SUBJECT: MAIN LANDING GEAR RETRACTING LINK BOLT REPLACEMENT

AFFECTED: M20F - S/N 660003 thru 22-1439  
M20J - S/N 24-0001 thru 24-0609

COMPLIANCE: MANDATORY compliance within 90 days of notification.

FIGURE 212-1

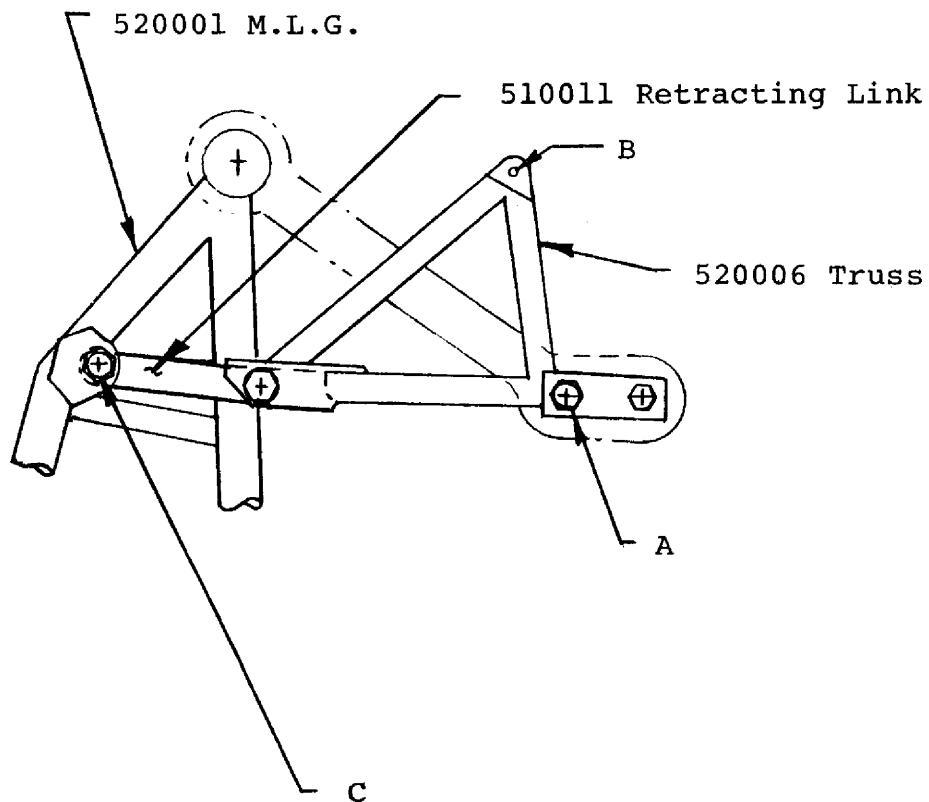
NOTE: Steps 3 thru 12 apply to both left and right main gear and should be performed one gear at a time. Refer to Figure 212-1 for proper orientation.

3. Remove bolt at position B, attaching tube to retraction truss. Retain for re-installation.
4. Remove bolt at position A, attaching retracting truss to fitting.
5. Remove nut from bolt attaching link to main landing gear at position C.

6. Remove four bolts from rear attachment bracket and slide gear and bracket outboard and upward into outboard corner of wheelwell.
7. With rear attach point of gear held in corner of wheelwell retract gear about 15° or until bolt attaching retracting link to gear can be removed.
8. Install NAS 1306-29 bolt (2.3 inches long) in main landing gear re-attaching retracting link while gear is held in canted position.
9. Slide rear attach point of gear and rear attach bracket back into place and install the four attaching bolts.
10. Install new AN 363-624 nut (and washer as required) on main landing gear attaching link, position C.
11. Install NAS 1306-20H or 1306-21H bolt as required thru retracting truss and fitting, position A. (Re-safety wire).
12. Re-install bolt, washer and nut thru tube and retracting truss, position B.

- A. Remove AN6H-17A or 914006-503 bolt.  
Install NAS 1306-21H or 1306-20H bolt  
as required.
- B. Retain hardware for re-installation.
- C. Remove AN6-22A bolt.  
Install NAS 1306-29 bolt (2.3 inches long)  
and new AN 363-624 nut.
